### Attachment 2 to PLA-6138

Non-Proprietary Version of the PPL Responses

# Figure 3 - Second Bank Strain Gauge S5 Response as a Function of Power [[

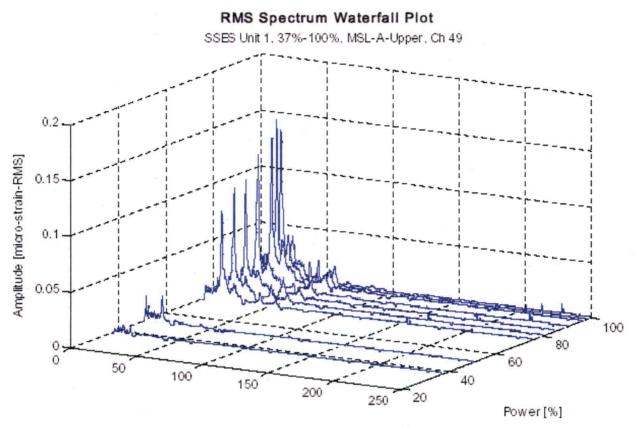
The licensee's submittal indicates the presence of a strong spectral peak at about 110 Hz in the SSES 1 and 2 plant measurements on the steam dryer. The licensee should discuss the source of this peak and the absence of its prediction in the analysis.

The frequency of the observed panel resonance matches the recirculation pump vane passing frequency corresponding to the core flows and recirculation pump speeds present when the measurements were made. The 110 Hz peak observed in the second bank hood panel strain gauge measurements is due to a local structural resonance in the panel where strain gauges S4 and S5 were located. The dryer panels are responding to a strong vibration response in the recirculation loop piping that is excited by the recirculation pump vane passing frequency. The piping vibration is transmitted through the vessel to the dryer supports. This recirculation piping vibration response was first observed in SSES Unit 2 when the plant entered the Increased Core Flow (ICF) region for the first time following licensing of the ICF region.

The recirculation pump vane passing frequency matched a structural mode of the panel at the core flow conditions when the measurements were taken (110 Hz at 100% OLTP and 113 Hz at 90% OLTP). The 110 Hz response was noted at that time of the measurements, as determined in MDE-199-0985-P, Revision 1, which is provided as Appendix 1 of this letter. At that time, the source of the resonance was not investigated. Structural analyses in MDE-199-0985-P, Revision1 determined that the 110 Hz frequency was a structural mode of the second panel. These conclusions were confirmed by performing a vibration analysis using the current whole dryer finite element model. The fatigue evaluation presented in Attachment 10 considered flow-induced vibration resulting from pressure loads applied directly to the dryer. Because the 110 Hz vibration load was transmitted mechanically through the dryer supports, it was not predicted in the pressure load Flow Induced Vibration (FIV) analysis presented in Attachment 10 of PPL's CPPU submittal.

Figures 2 and 3 show the frequency spectra for the second bank strain gauges for power levels from 70% to 100% OLTP. In Attachment 10, a scaling factor was developed in order to adjust the predicted stress results from the finite element analysis to be equivalent to the stresses indicated by the in-plant dryer instrumentation. The scaling factor was based on a comparison of the predicted strains to the measured strains for S4 and S5 at the 100% OLTP power case where the 110 Hz peak is the highest. As discussed above, the 110 Hz peak shown in Figures 2 and 3 were correlated to the recirculation pump vane passing frequency. Because this dominant peak is based on the

recirculation pump vane passing frequency and a local structural resonance, a stress under prediction factor based on it will be bounding for the other power levels. Without the 110 Hz peak, the stress under prediction factor would be approximately 30% lower. The rest of the frequency spectrum is proportional to steam flow during the power ascension. The pressure loads, as shown by the pressure drum (Figure 4) and steam line pressure measurements (Figure 5) are also proportional to steam flow as power increases. If the 110 Hz peak were not present, a scaling factor based on the measured strain gauge response would be relatively constant as power increased. Strain gauges S4 and S5 were located on the second bank panel near the high stress location where the weld seam cracked during the first cycle. It is most likely that the 110 Hz peak is a local structural resonance in this panel caused by the vibrations introduced by the recirculation pump vane passing frequency. The structural performance of the dryer over more than 20 years suggests that there are no other locations on the dryer that are experiencing high stresses as a result of the recirculation pump vane passing vibration.

Note: The 110 Hz peaks shown in the plot are due to the mechanical excitation of pressure drum diaphragm by the recirculation loop vibration (confirmed by a vertical accelerometer mounted next to one of the pressure drums).
